SUBJECT: COMANCHE PEAK STEAM ELECTRIC STATION
DOCKET NOS. 50-445 AND 50-446
SUPPLEMENT TO LICENSE AMENDMENT REQUEST (LAR) 07-006
RESPONSE TO REQUEST FOR ADDITIONAL INFORMATION RELATED TO
PROPOSED TECHNICAL SPECIFICATIONS REVISION TO REFLECT
CYCLE-SPECIFIC SAFETY ANALYSIS ASSUMPTIONS REGARDING ADOPTION OF
WESTINGHOUSE METHODOLOGIES
(TAC NOS. MD6561 AND MD6562)

**Response to NRC Request for Additional Information
related to License Amendment Request (LAR) 07-006**

**Response to NRC Instrumentation and Controls Branch
Request for Additional Information dated November 19, 2007**

**Revised Markup to Technical Specifications
For LAR 07-006**

Figure 1. Nuclear Safety-Related Setpoint Relationship

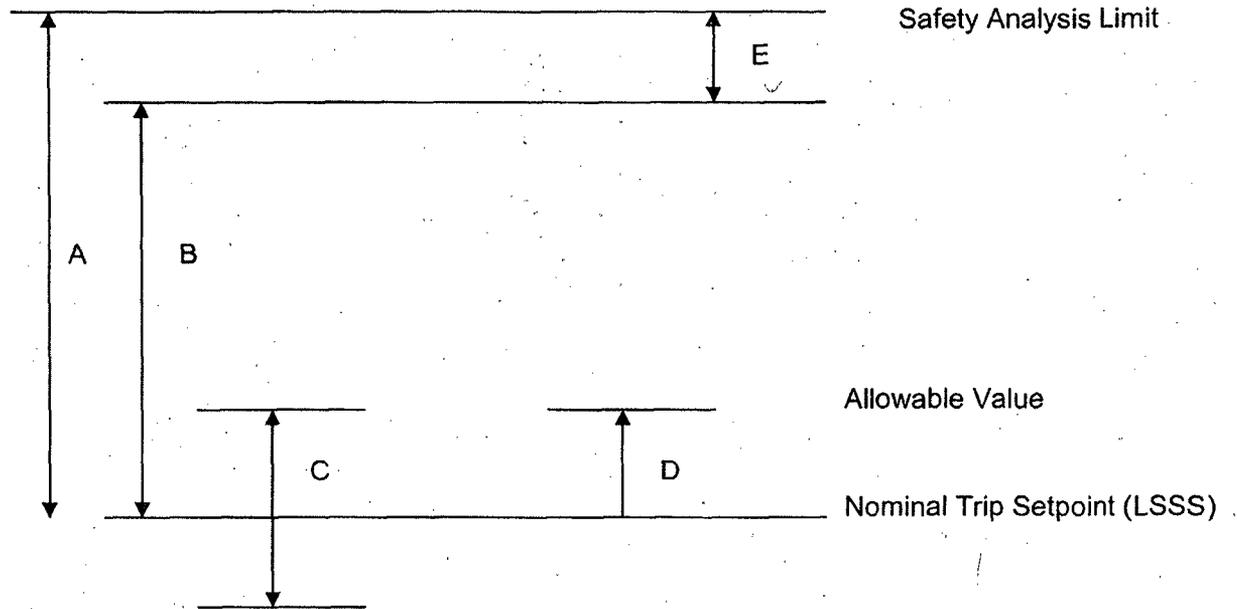
For the changes to the Allowable Values in TS Tables 3.3.1-1 and 3.3.2-1, provide the following information:

Setpoint Calculation Methodology: Provide documentation (including sample calculations) of the methodology used for establishing the limiting setpoint (or NSP) and the limiting acceptable values for the As-Found and As-Left setpoints as measured in periodic surveillance testing as described below. Indicate the related Analytical Limits and other limiting design values (and the sources of these values) for each setpoint.

As noted in Section 4.0 of Attachment 1 of TXX-07108, the basic uncertainty algorithm used to determine the overall instrument uncertainty for the RTS/ESFAS trip functions is the square-root-sum-of-the squares (SRSS) of the applicable uncertainty terms. This is the same methodology as defined in WCAP-12123 as modified for term dependencies as shown on the attached tables. All appropriate and applicable uncertainties, as defined by a review of the plant baseline design input documentation, have been included in each RTS/ESFAS trip function uncertainty calculation (see attached calculations). This approach is consistent with NRC Regulatory Guide 1.105, Revision 3, "Setpoints for Safety-Related Instrumentation," and ISA Standard 67.04.01-2006, "Setpoints for Nuclear Safety-Related Instrumentation." It is believed that the total channel uncertainty, or channel statistical allowance (CSA) calculated is at a 95 percent probability and 95 percent confidence level (95/95) as requested by Regulatory Guide 1.105.

In contrast with the methodology described in WCAP-12123, but consistent with the NRC's RIS 06-17 and the proposed TSTF-493, Revision 2, the Allowable Values (AVs) for the Comanche Peak Technical Specifications changed for this LAR are determined by adding (or subtracting) the calibration accuracy, defined by the RCA term (see attached Tables), of the tested channel during the Channel Operational Test to the NTS in the non-conservative direction (i.e., toward or closer to the SAL) for the application. The magnitude of the as left (calibration accuracy term) and the as found tolerances are the same and are specified in the station procedures. It is noted in the attached tables that there are differences in the Unit 1 and Unit 2 steam generator level uncertainties due to the physical differences in steam generator design (model $\Delta 76$ versus model D5) including generator geometries and instrument tap locations. These differences result in different instrument spans and thus variation in the PMA and instrument uncertainty allowances.

This methodology is described in the proposed BASES to TS 3.3.1. Figure 1 provides a visual description of the setpoint relationships. This methodology has been recently reviewed and approved by the NRC for the Beaver Valley Power Uprate Program and the Callaway Replacement Steam Generator (RSG) Program.
